Hillend's mountain coaster at Cairn Gorm (2) - what is the likely impact?

Photo credit Planning and Design Statement ?? no maintenance track in site!

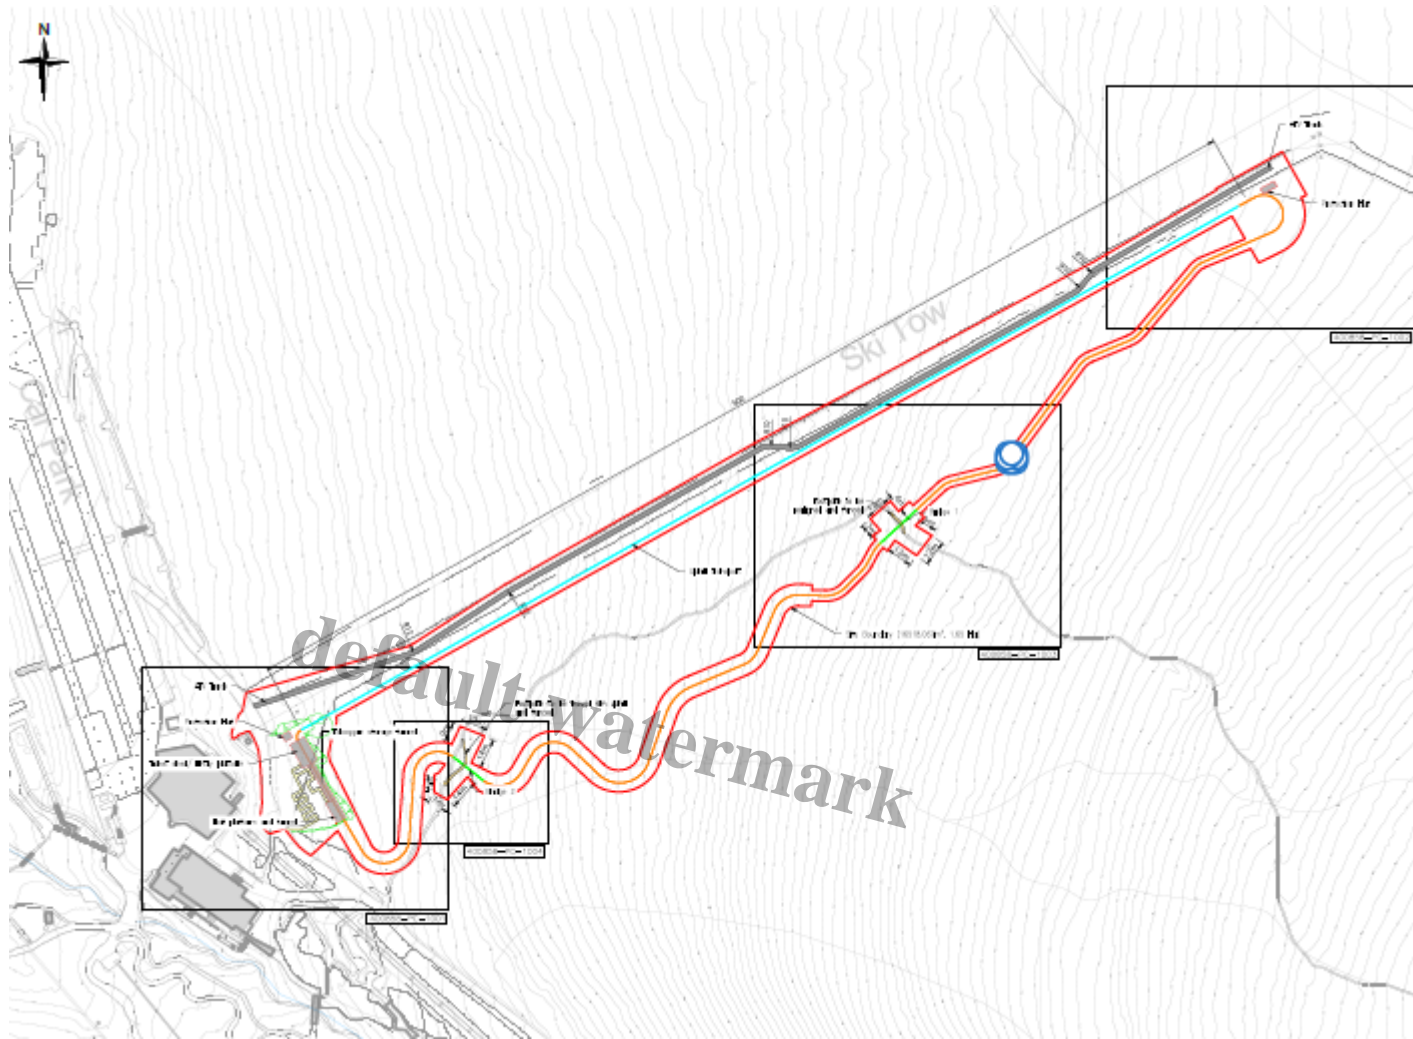
Just why HIE/CMSL believe its possible to construct the coaster without a track but one is needed for maintenance purposes is not explained. With Mike Gifford??s clarification I was able to work out that whatever the other documents state or show, the proposed Site Layout Plan appears to be correct (although the existing Poma lift is not clearly shown):

Site Layout Plan courtesy the planning documentation. The grey line = the proposed permanent access track; the straight blue line the route of the coaster as it carries people uphill; and the squiggly lines mark the descent.

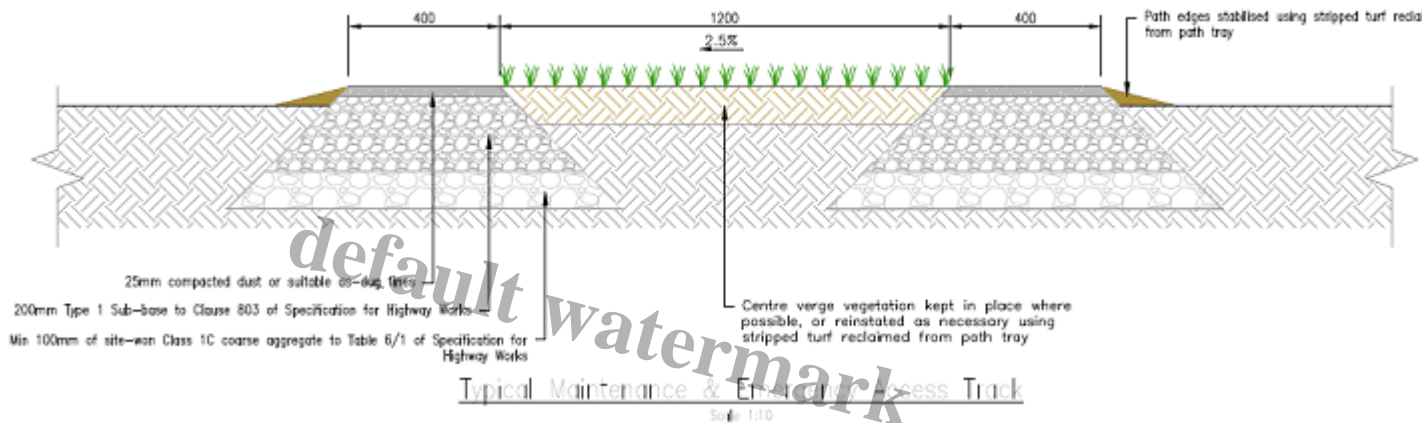
The Site Layout Plan shows that the proposed permanent track will be of very limited use for maintenance and emergency purposes because it would be separated from the longer downhill length of coaster track by the uphill coaster track which forms a barrier to vehicles. Since any accidents requiring emergency help are most likely on the downhill section of coaster track, the proposed access track appears to be in the wrong place. That raises questions about its real purpose.

The Site Layout Plan shows the proposed access track is not straight and takes a distinct kink towards the coaster uplift halfway up. How the straight poma and kinked track will fit is not described, nor are the implications for snowsports.

Fig 05 showing the potential extent of woodland creation above the Day Lodge and car park which was agreed as part of a Woodland Strategy adopted in 2019. The light green shows the woodland creation to date.

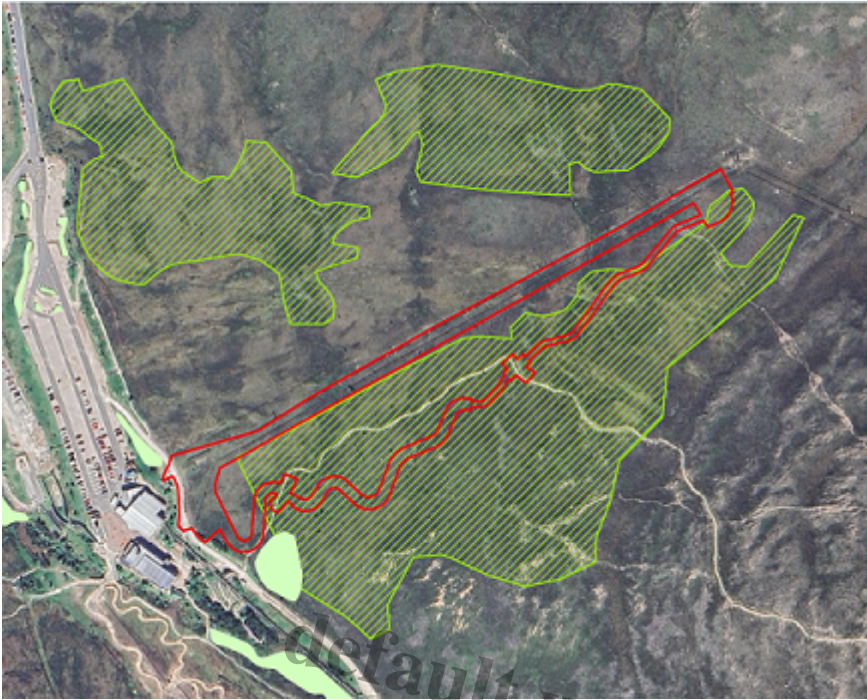
The LVA is correct to state that woodland, whether planted or naturally regenerating as at present, could in time screen most of the proposed coaster infrastructure and preventing reflections from the metal structure being visible from afar (there is a question about trees here would ever grow high enough to conceal the bridges). The LVA, however, refers to woodland planting as a possibility rather than a concrete plan and whether anything happens would appear to depend on funding from HIE.

That lack of certainty about funding raises the question why CMSL did not ask the Spey Catchment Initiative to plant trees above the Day Lodge, rather than giving the go ahead to the montane woodland project last year ([see here](#))? The slope above the Day Lodge would have been a far less controversial site.
